BPC Central Small Diameter Package 4C
Solicitation Number: CO-00487
Job No.: 20-4523

ADDENDUM 1
November 3, 2021

Dwg. No. **G-003**

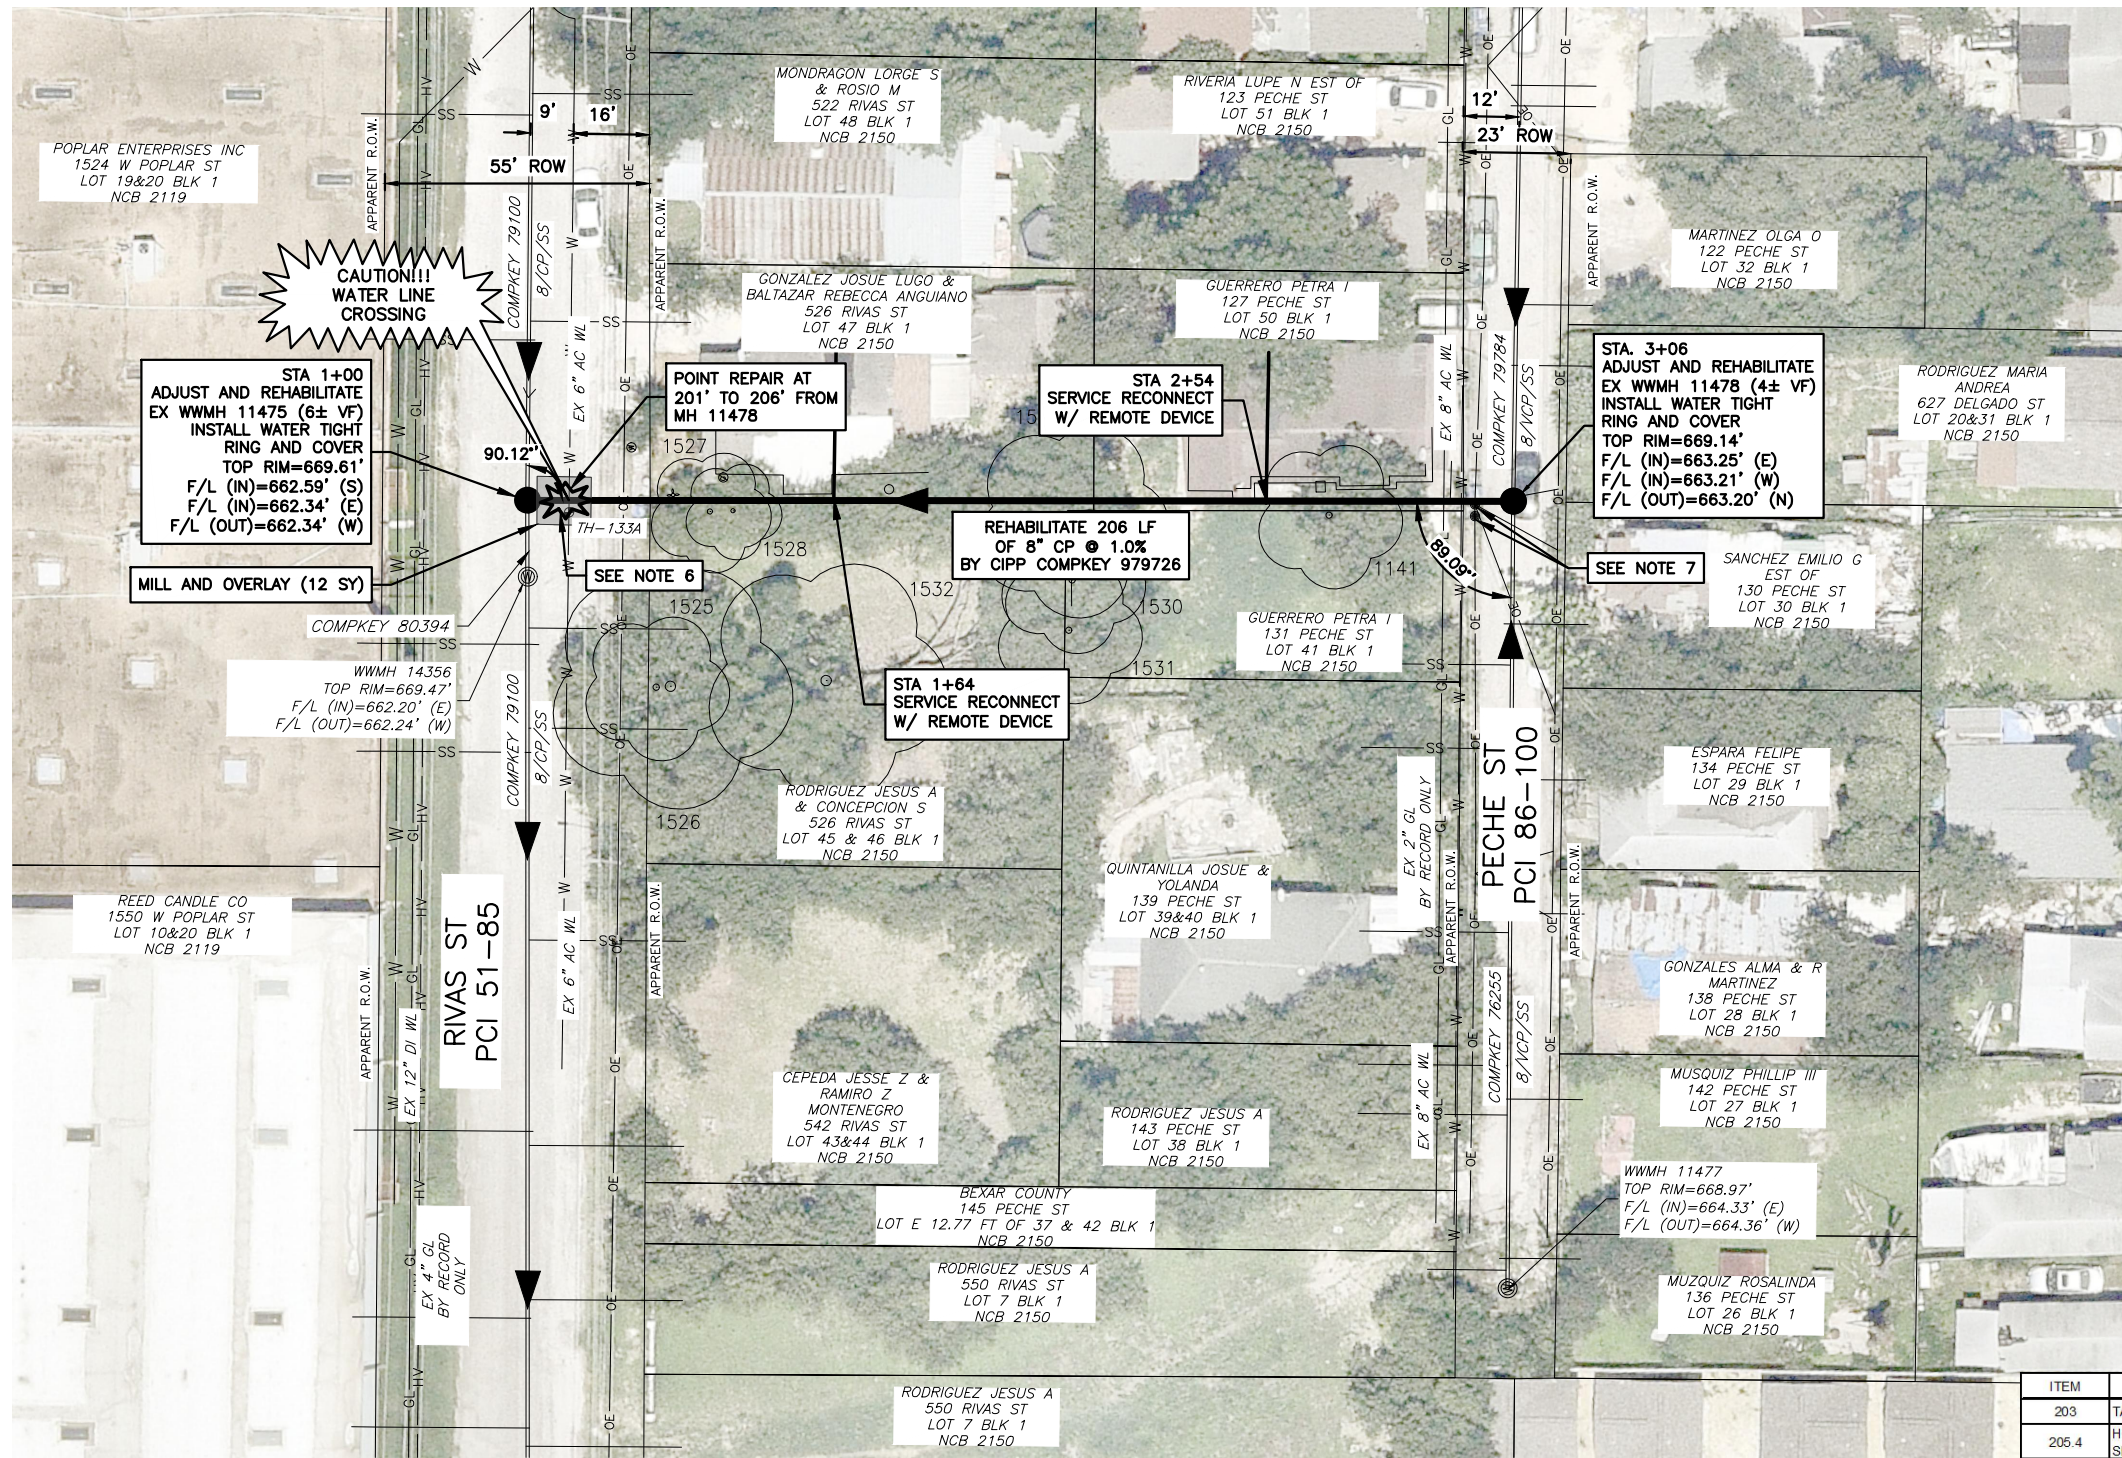
REMOVE Sheet G-003 in its entirety and REPLACE with the attached version. The following items were updated:

- a. REMOVE Item No. 11, Spec No. 507.1 “Chain Link Wire Fence (4’ High) (COSA Spec)” ; REMOVE Item No. 12, Spec No. 507.2 “Chain Link Wire Fence (6’ High) (COSA Spec)” ; REMOVE Item No. 13, Spec No. 507.6 “Wooden Fence (6’ High) (COSA Spec)” ; and REPLACE with Item No. 72, Spec No. SP 2010 “Removal and Replacement of Fencing”, Qty “750 LF”
- b. ADD Item No. 31, Spec No. 540 “Stormwater Pollution Prevention Plan”, Qty “1”, Unit “LS”.
- c. REMOVE Item No. 66, Spec No. 901.3 “Point Repair, All Sizes (0’-10’)(All Depths)”, and REPLACE with Item No. 66, Spec No. 1103 “Point Repair, All Sizes (0’-10’)(All Depths)”.
- d. All Item No.’s revised accordingly.

Dwg. No. C-133

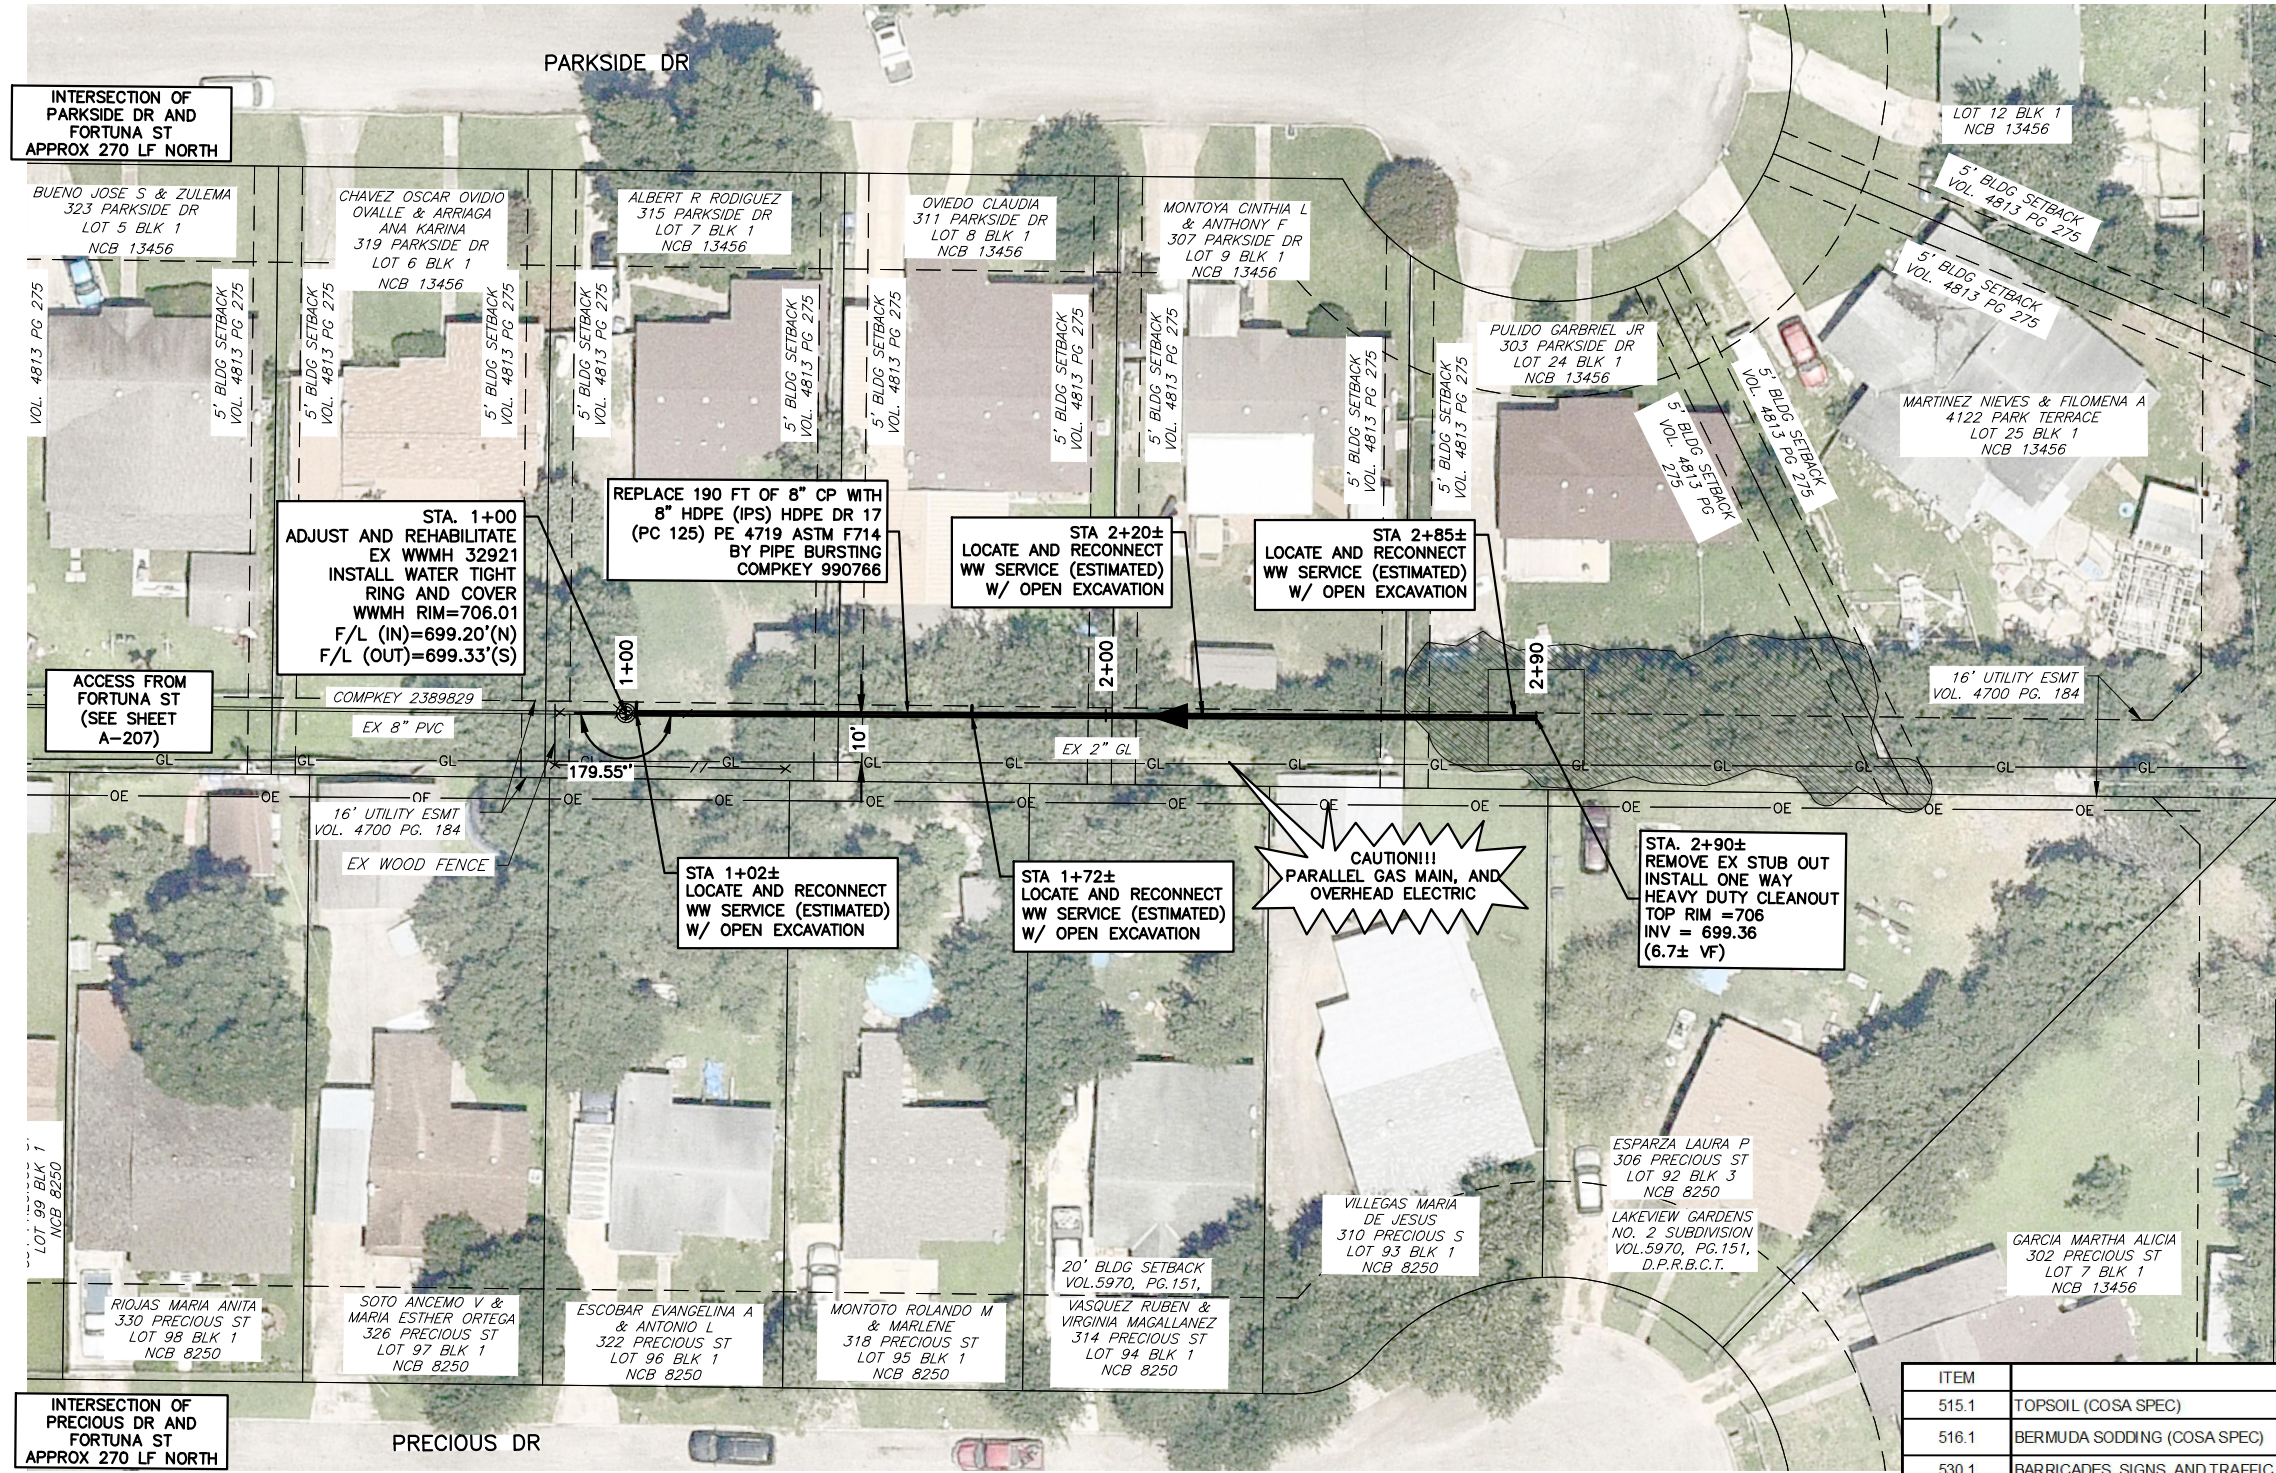
REMOVE Sheet C-133 in its entirety and REPLACE with the attached version. The following items were updated:

- a. In the sheet’s quantity table, REMOVE Item 901.3 “Point Repair, All Sizes (0’-10’)(All Depths)”, and REPLACE with Item No. 1103 “Point Repair, All Sizes (0’-10’)(All Depths)”.

Seq. 15 of 90
 Dwg. No. C-207

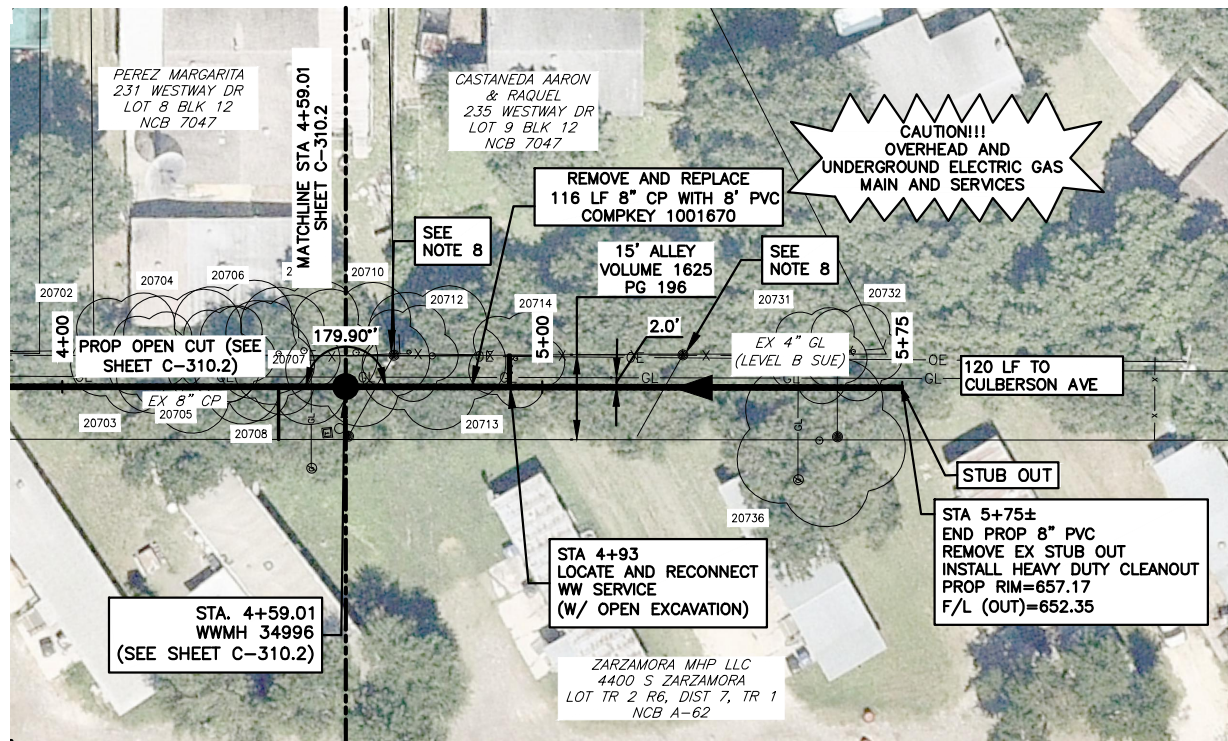
REMOVE Sheet C-207 in its entirety and REPLACE with the attached version. The following items were updated:

- a. In the sheet's quantity table, REMOVE Item Nos. 507.1 "Chain Link Wire Fence (4' High) (COSA Spec)" and 507.6 "Wooden Fence (6' High) (COSA Spec)", and REPLACE with Item No. SS-2010 "Removal and Replacement of Fencing", Qty "320 LF".

Seq. 31 of 90
Dwg. No. **C-310.3**
0535-015-01

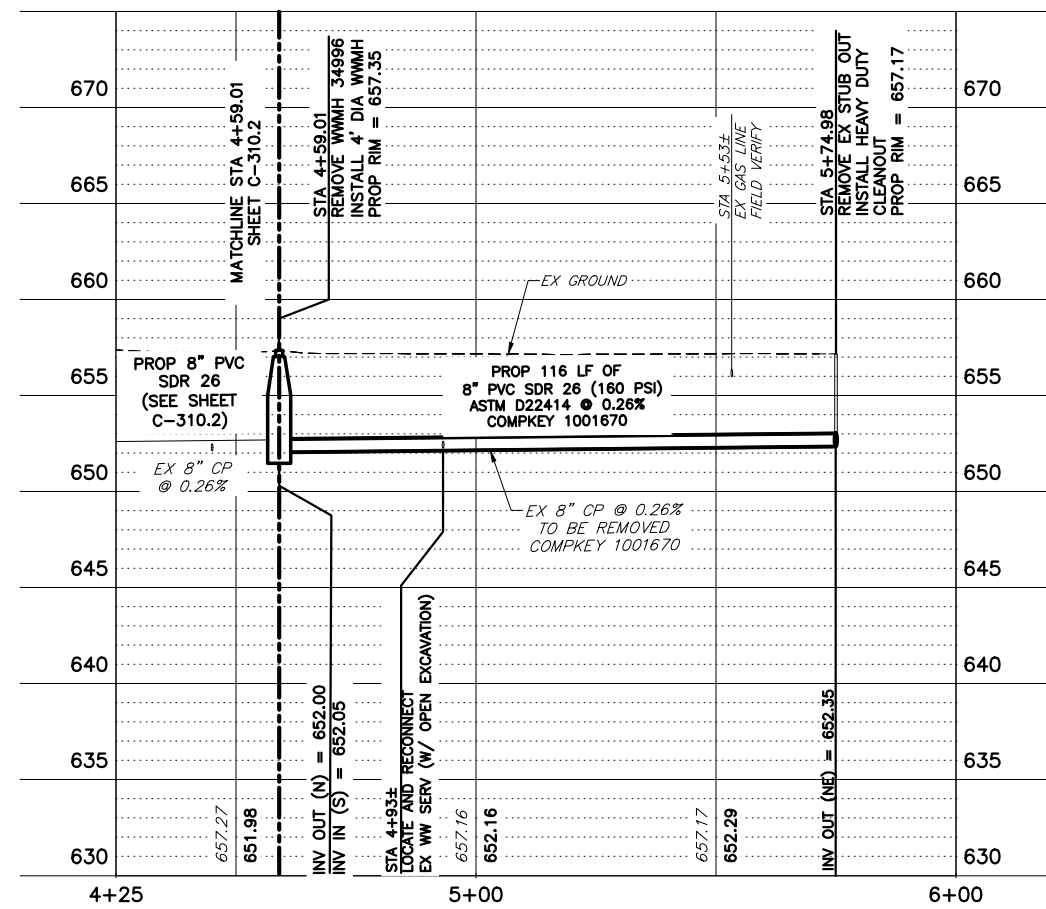
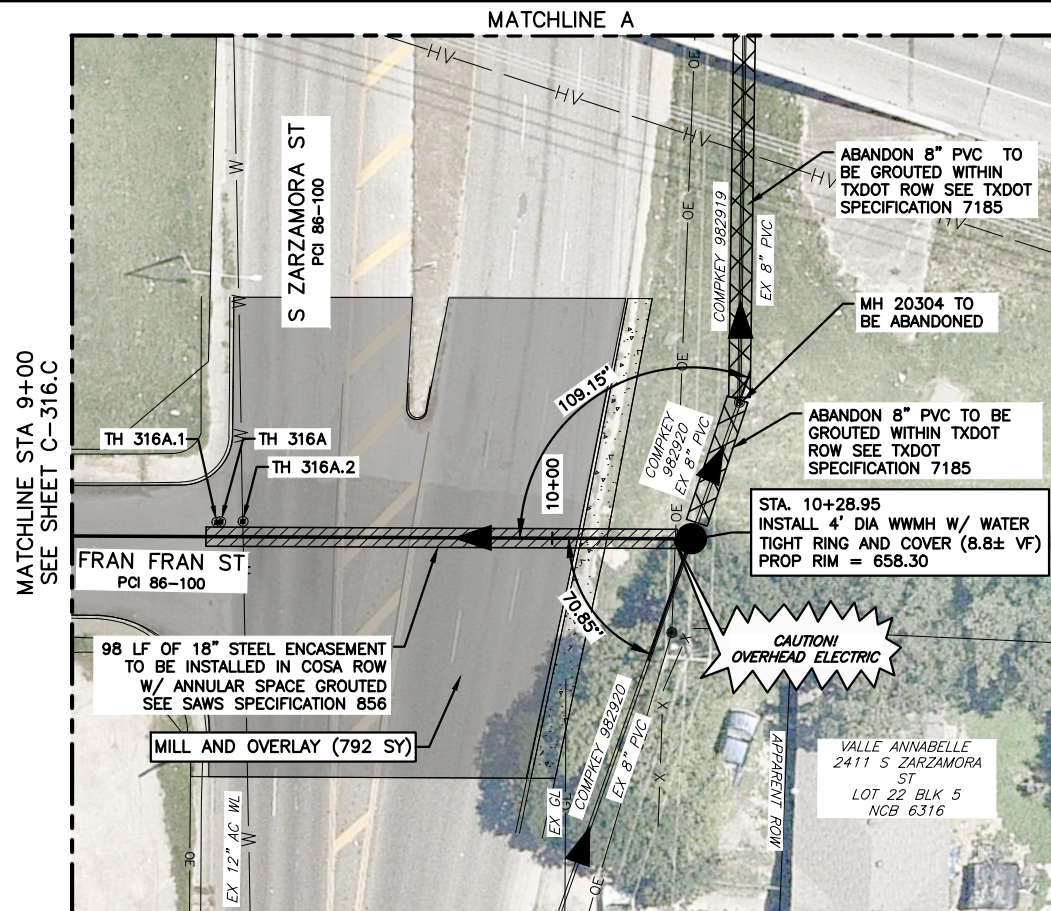
REMOVE Sheet C-310.3 in its entirety and REPLACE with the attached version. The following items were updated:

- a. In the sheet's quantity table, REMOVE Item No. 507.2 "Chain Link Wire Fence (6' High) (COSA Spec)", and REPLACE with Item No. SS-2010 "Removal and Replacement of Fencing", Qty "25 LF".
